81-103 King's Road

Welcome to our second round of Community Meet and Greet events.

As previously noted during the last round of consultation events held in May, the design team have undertaken a review of the consented scheme, alongside supporting information including the fire strategy, and new survey information. This review has resulted in the team identifying several minor amendments that will be required to deliver the consented building.

Proposed Amendments

Ground Floor - Proposed

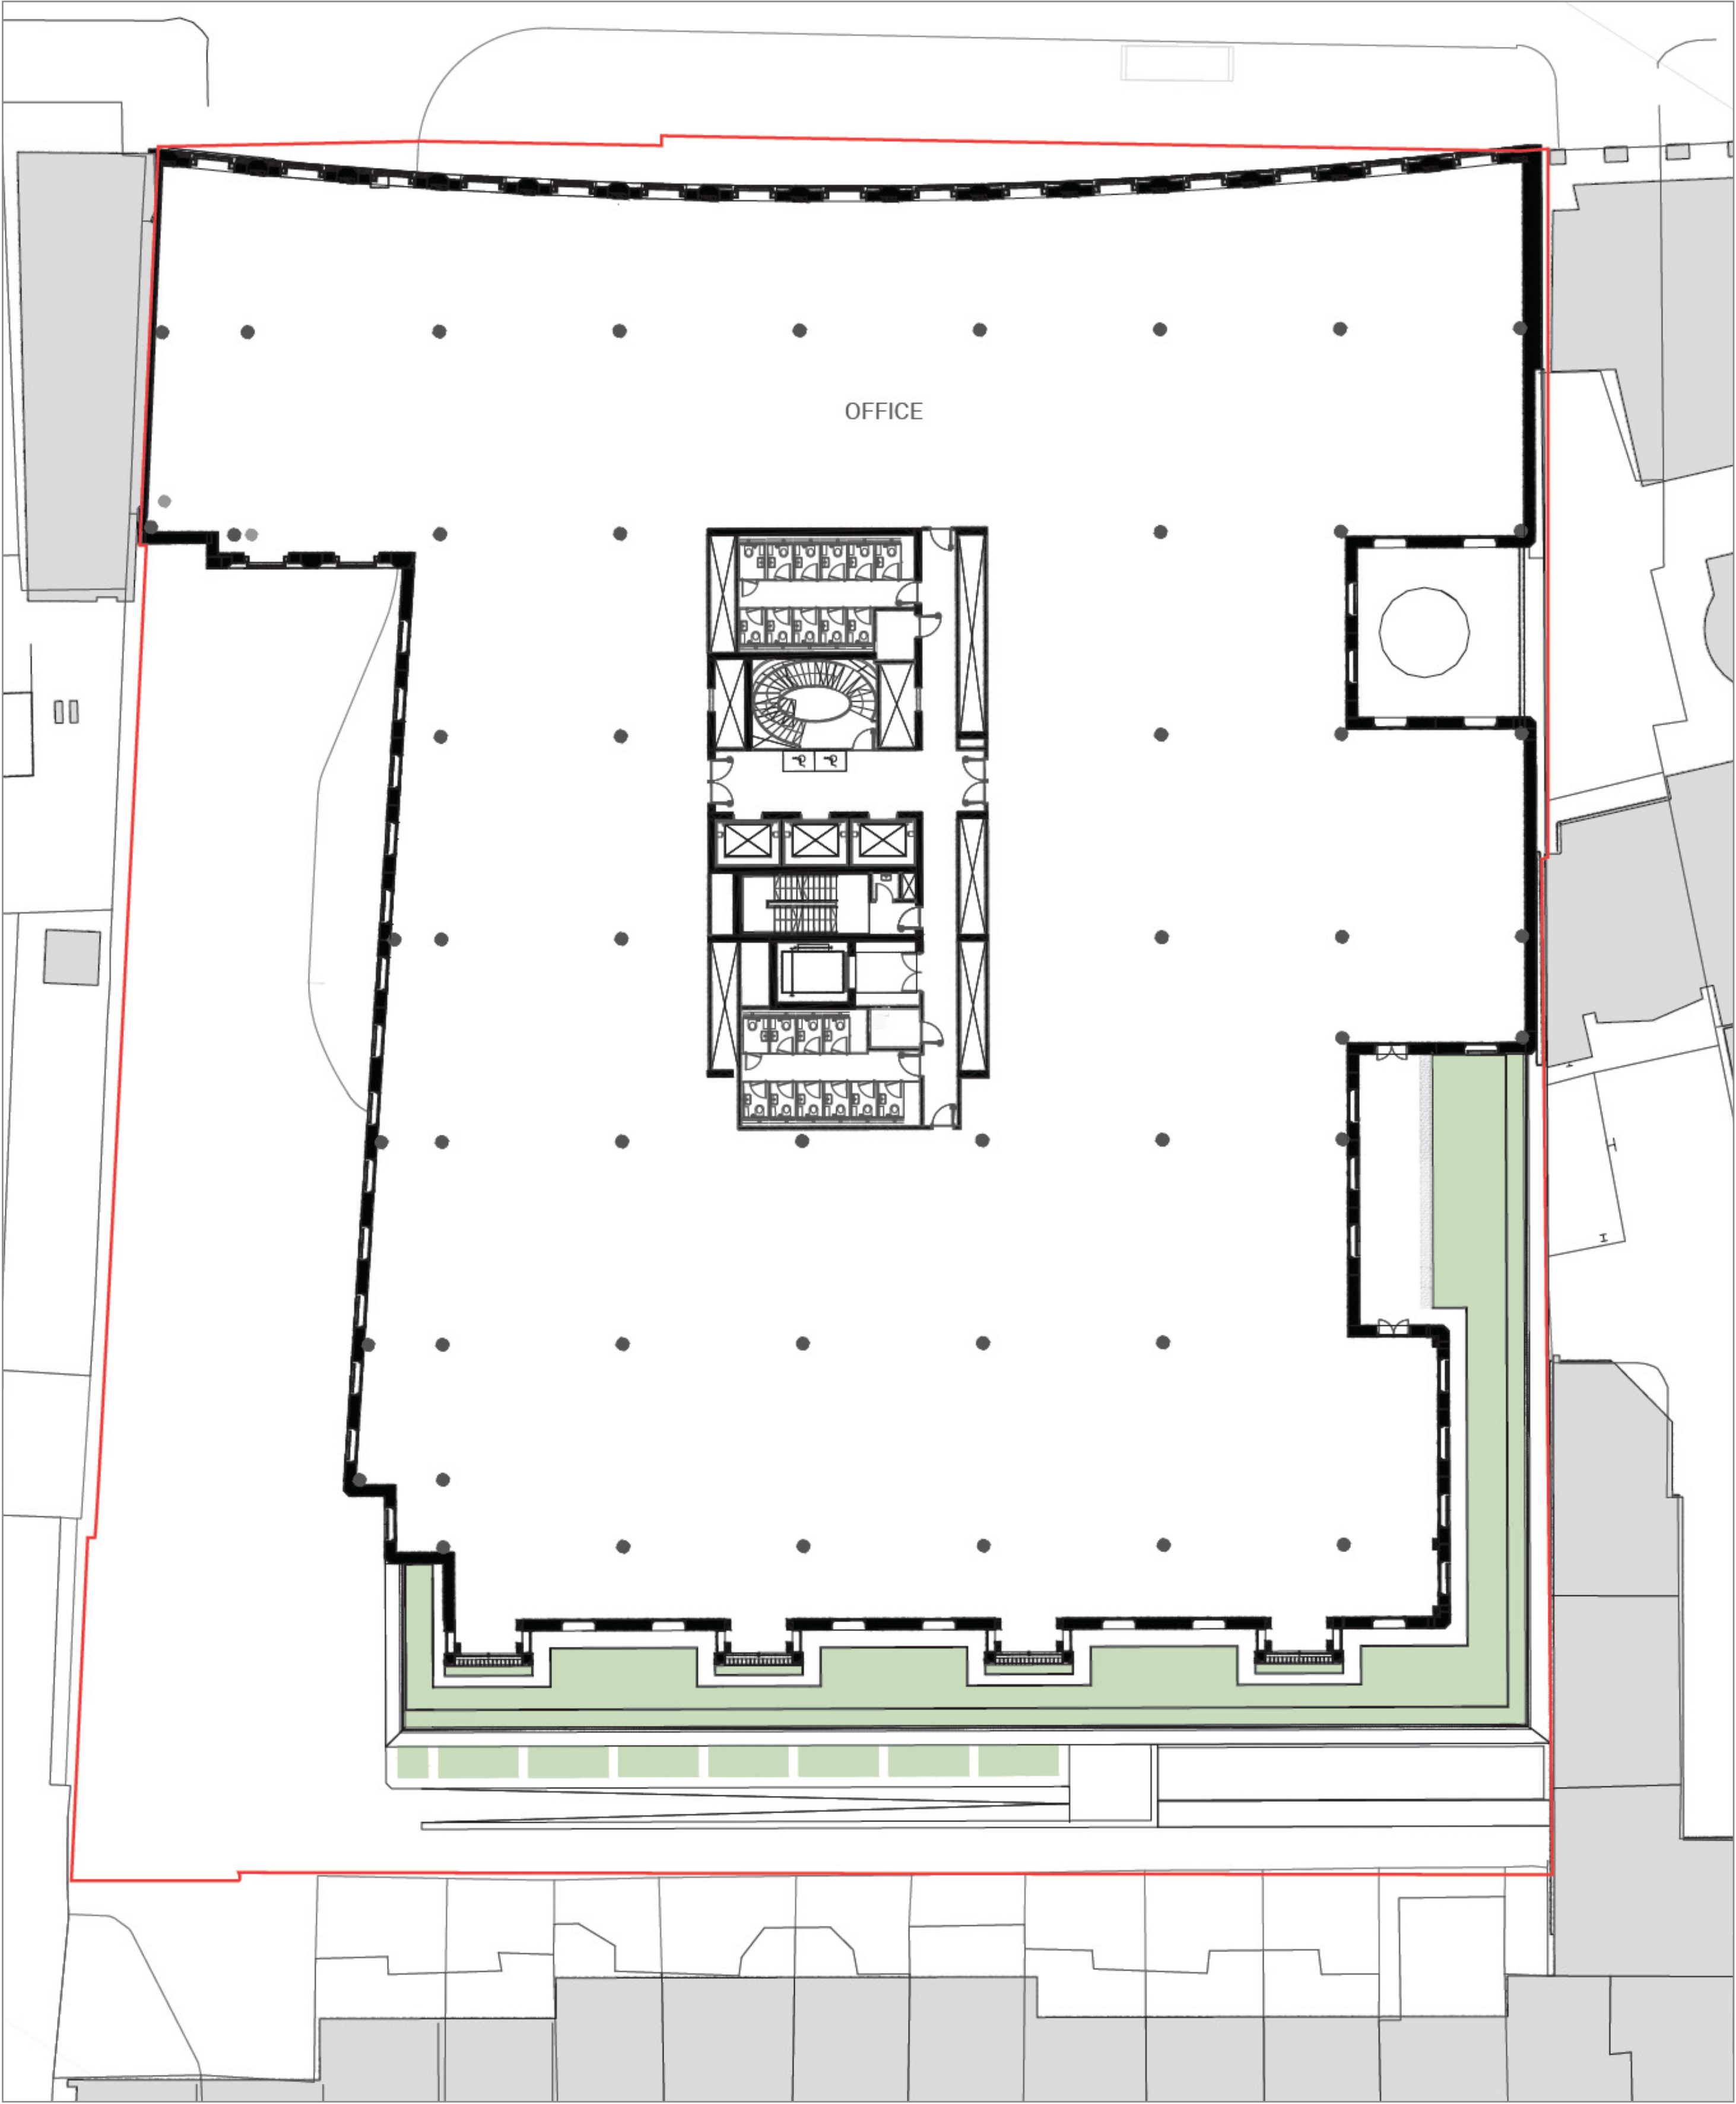
- Fire safety measures have been enhanced, with a new firefighting access route from King's Road, widened internal staircases, and adjusted escape paths, including the relocation of a stair previously exiting onto Charles II Place (CIIP).
- The proposed refinements to the scheme include a centrally relocated office entrance, leading to reconfigured office and retail spaces that improve functionality while preserving the building's character.
- On the western façade, a straighter alignment is planned to simplify the structure, enhance access to the service road, and reduce embodied carbon.
- Updated landscaping to reflect re-instatement of the existing service road entrance.

First Floor - Proposed

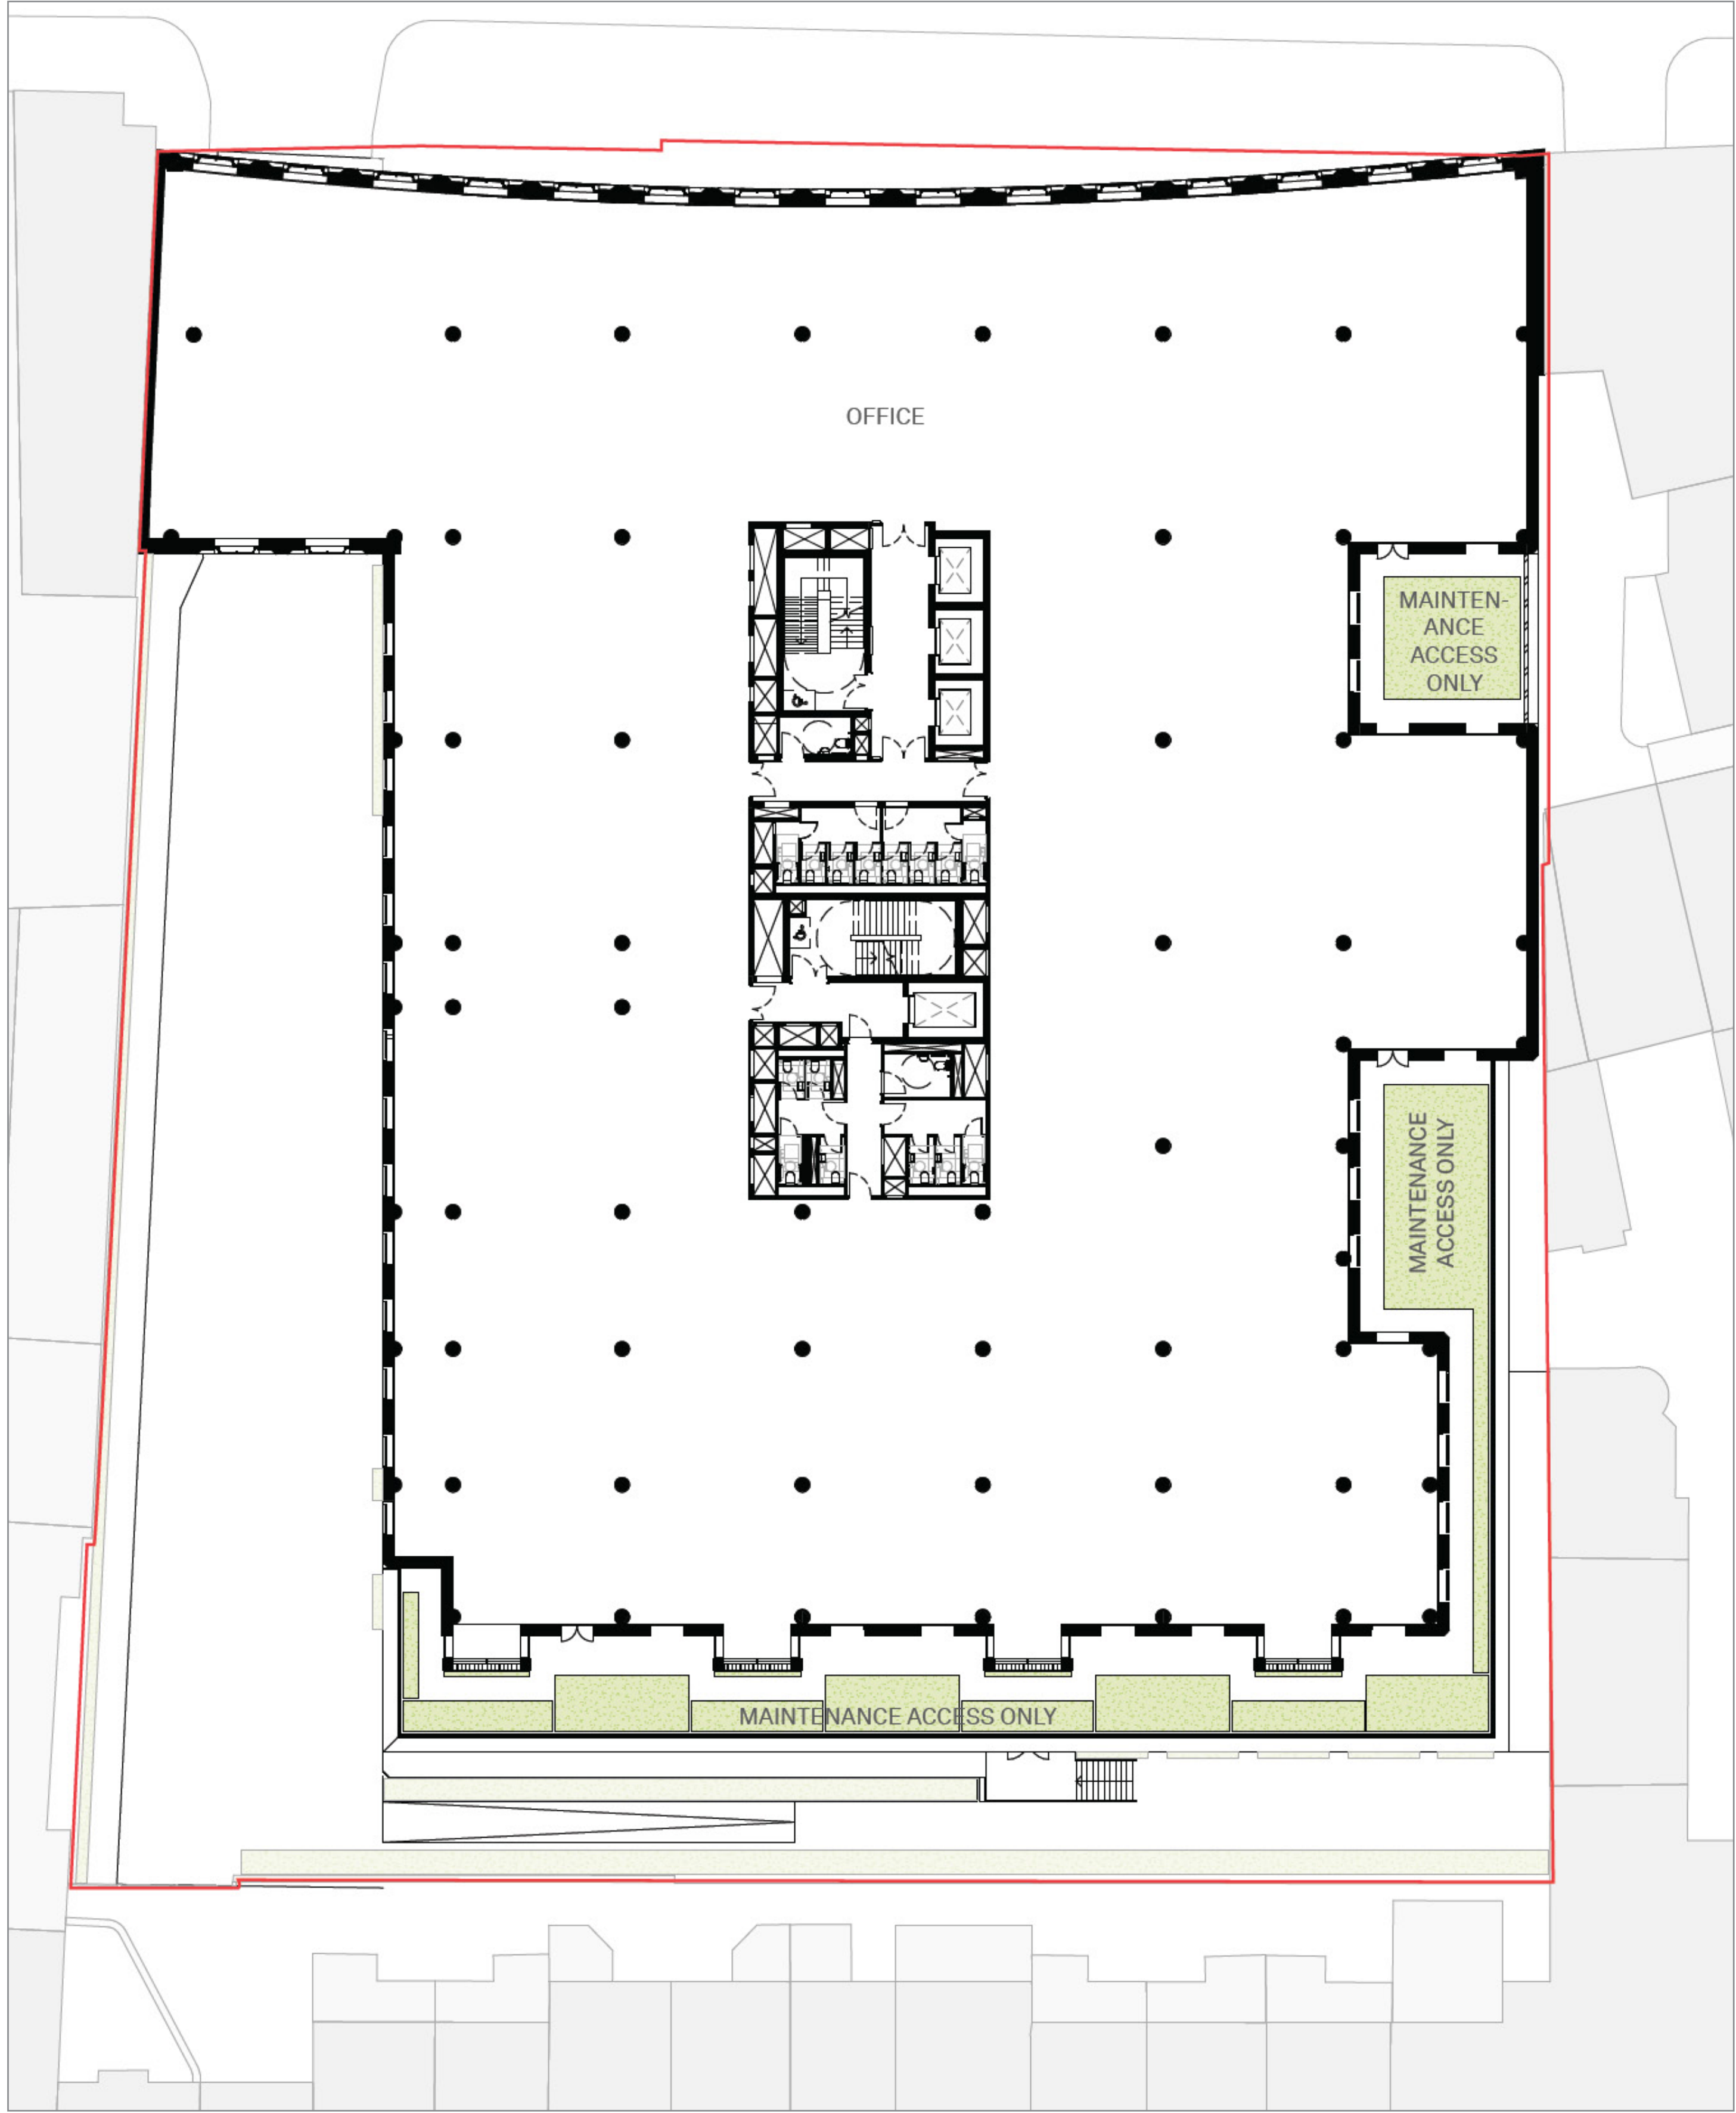
- Green shop front awnings will be removed.
- The first-floor terrace is to be reduced to accommodate a new ground floor escape route.
- MEP revisions include new UKPN substations at ground level, an expanded basement plant area, and equipment relocation to optimise space.
- We are proposing a shift in the building's mechanical strategy, compared to the existing consent. This involves moving away from a centralised plant system in favour of an on-floor approach.
- The proposed change avoids the need that otherwise arise to substantially increase the plant volume at roof level and enables some tall equipment — originally planned for the basement (too tall to fit) — to be relocated without increasing the plant screen height.
- This approach will also see equipment redistributed to ceilings within office floors.
